# TOWN OF HORIZON CITY Planning and Zoning Commission Staff Report

Case No.: SDP25-0003 Rancho Desierto Bello Unit 19

Application Type: Preliminary Subdivision Plat Application

**P&Z Hearing Date:** June 16, 2025

# **Attachment 4: Preliminary Subdivision Plat**

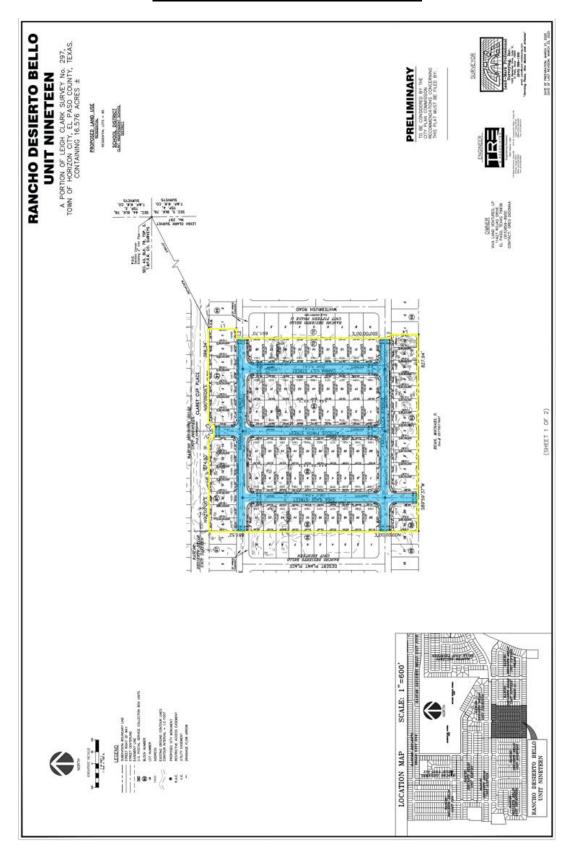
Can you please clarify how the drainage is planned to be managed? It appears that runoff from Chia Sage Street is simply proposed to be discharged onto undeveloped land to the west. Is that a temporary condition until Unit 18 is constructed?

Please change the R.A.E. easement to Utility Easement. We have an existing easement along Claret Cup Pl.
